MANDATORY SERVICE BULLETIN Z 242L/63a

- 2. APPLICABLE TO:** All Z 242L aircraft's from S/N 0741 incl. to S/N 0799 incl. with adjustable foot control.

- 3. REASON:**

Original clamp position:

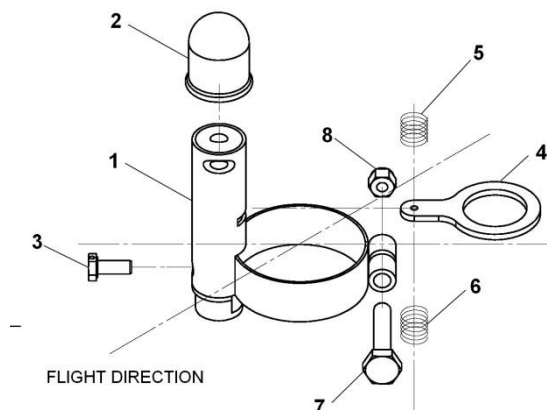
Inaccurate defining of the installed clamp in parking brake attaching clamp in the Maintenance Manual. During maintenance (disassembly and subsequent assembly of the clamp) could be improper adjusting and subsequent colliding clamp and rudder pedals when setting the rudder pedals to the front position.

- 8. PROCEDURES:**
 - a) Check the location of the attaching clamp in parking brake on left brake cylinder. In case of collision with the pedals rotate it into required position (see following figure). Verify no conflict in front and rear pedal control position.

Possible rotation of the clamp in the required position:
